PLANNED UNIT DEVELOPMENT (PUD) AND PRELIMINARY PLAN

County File Number: PUDSP208

MEADOWBROOK PARK PLANNED UNIT DEVELOPMENT (PUD) AND PRELIMINARY PLAN LOCATED IN THE SOUTHEAST 1/4 OF SECTION 8, T14S, R65W, OF THE 6th P.M., EL PASO COUNTY, COLORADO $\frac{\text{KEYMAP}}{\text{SCALE: 1"}} = 250'$ NOTES ALL BUILDINGS, LOTS 1-67, WILL BE CONSTRUCTED AS, SLAB ON GRADE, LOTS ARE NOT PERMITTED TO HAVE BASEMENTS. SIDE LOT SWALES ARE REQUIRED WITHIN EACH 6-FT CORRIDOR BETWEEN HOMES, PER THE TYPICAL DETAIL SHOWN HEREON. CORRIDORS BETWEEN HOMES SHALL NOT BE GRADED FLAT. 5' SIDE YARD SETBACK SETBACK MIN 1.00% ALONG FL-SIDEWALK WITH _ CURB & GUTTER FRONT ELEVATION __ AT BOW FRONT ELEVATION __ AT BOW PROPOSED SIDE LOT SWALE TYP. TYPE B LOT SECTION B-B TYPE A LOT SECTION A-A **CROSS SECTION** MEADOWBROOK PARKWAY DESIGNED BY: LM DRAWN BY: LM CHECKED BY: JEH DATE: XX/XX/2 PROPOSED SIDE LOT SWALE IN-BETWEEN CLAREMONT PARK SELF-STORAGE OWNER: GENE A & JOANN F MEEK REVOCABLE TRUST 50.0' PROPOSED PRIVATE ACCESS ESMT (TYP.) MEADOWBROOK PARK PLANNED UNIT DEVELOPMENT (PUD) PL 24/94 BUSINESS PARK FILING NO. 1 OWNER: CIRCLE K STORES INC. REC. NO. 217048353 60.0' CDOT DRAINAGE EASEMENT REC. NO: 201191298 US

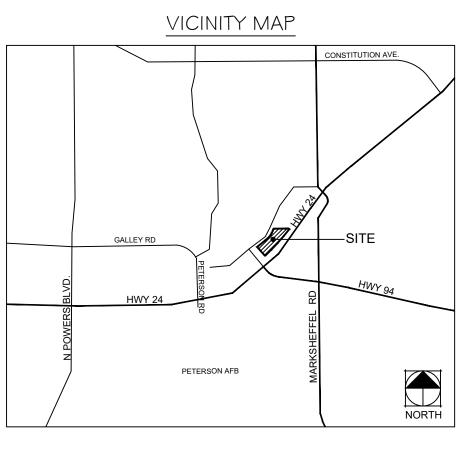
correct this note for second floor decks

02 of 11

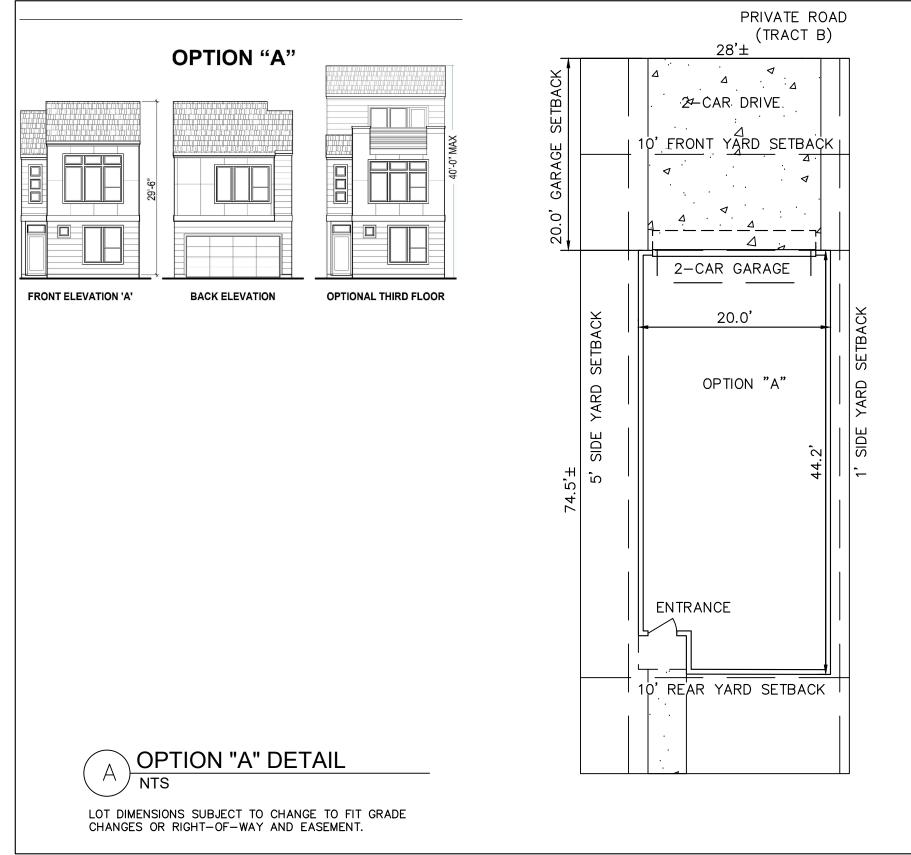
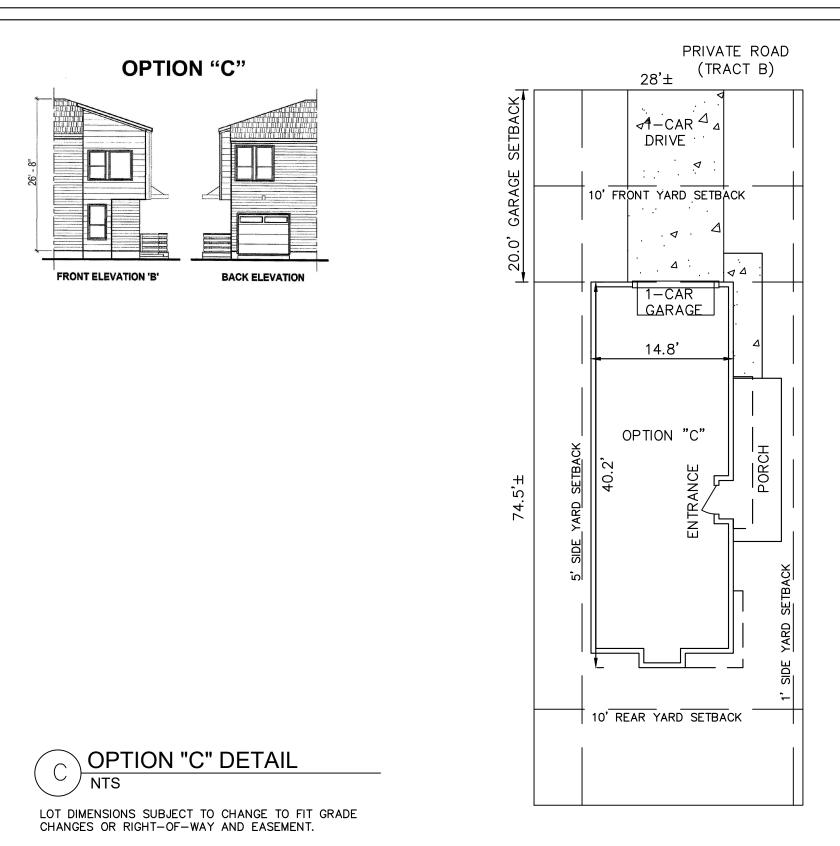
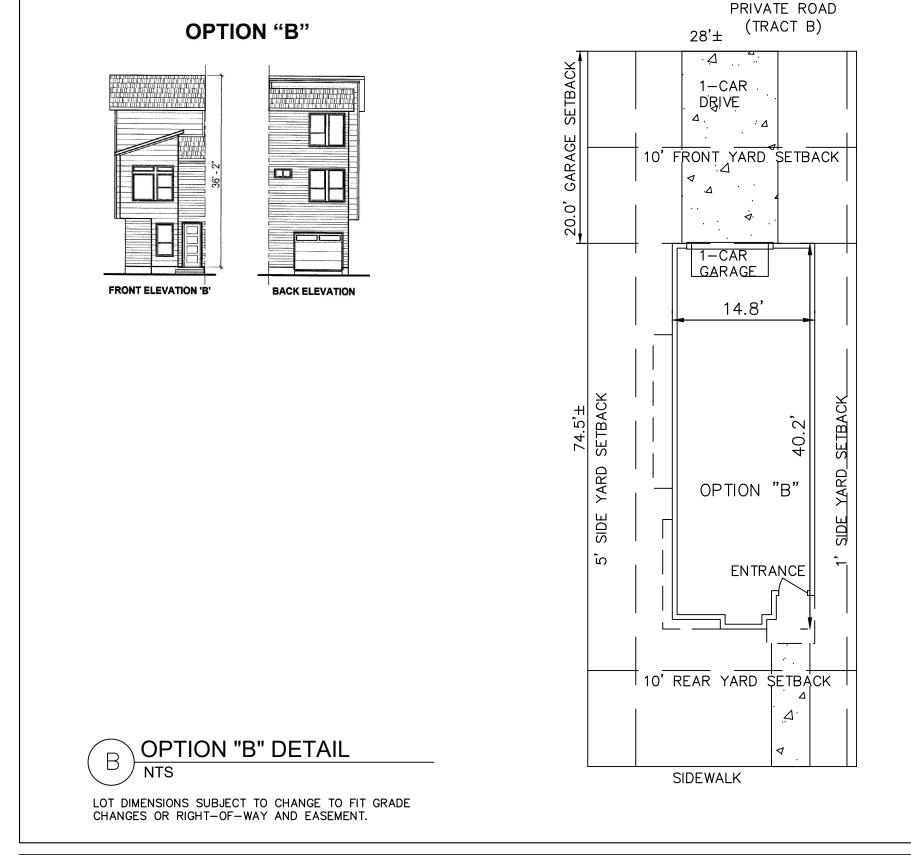
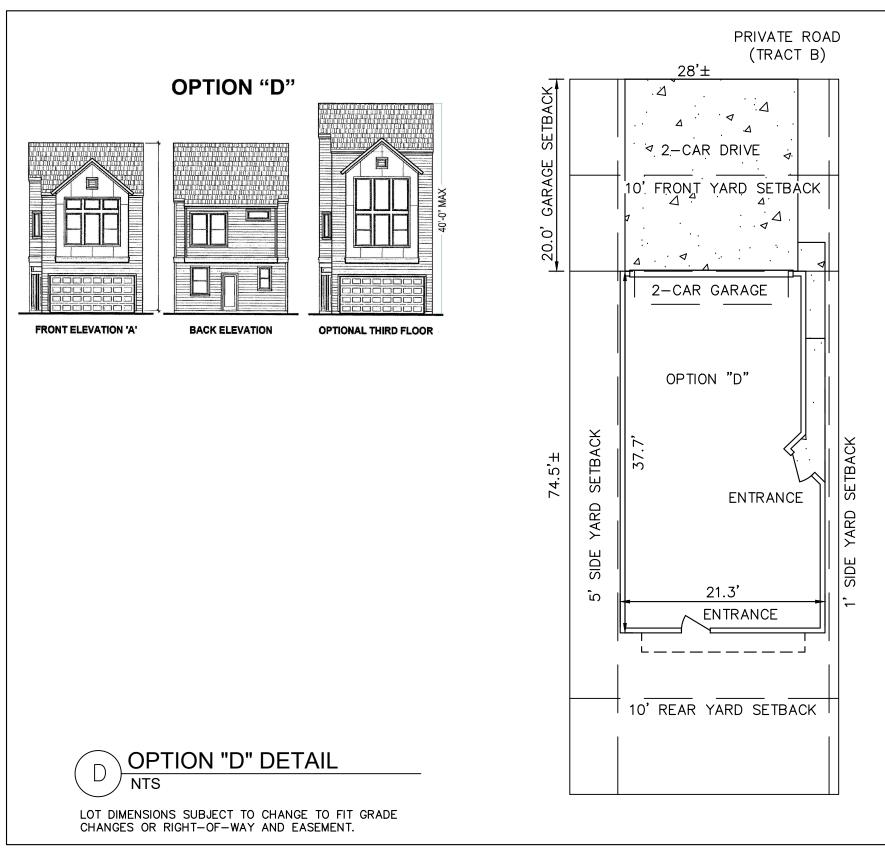
SEE NOTES 28 & 29 ON SHEET 1 AND NOTES 17 & 18 ON SHEET 2. THE INTENT IS, NO PORCHES/DECKS/OVERHANGS SHALL NOT ENCROACH UPON SAID EASEMENT AND SETBACK, EXCEPT FOR EAVES 12" OR LESS
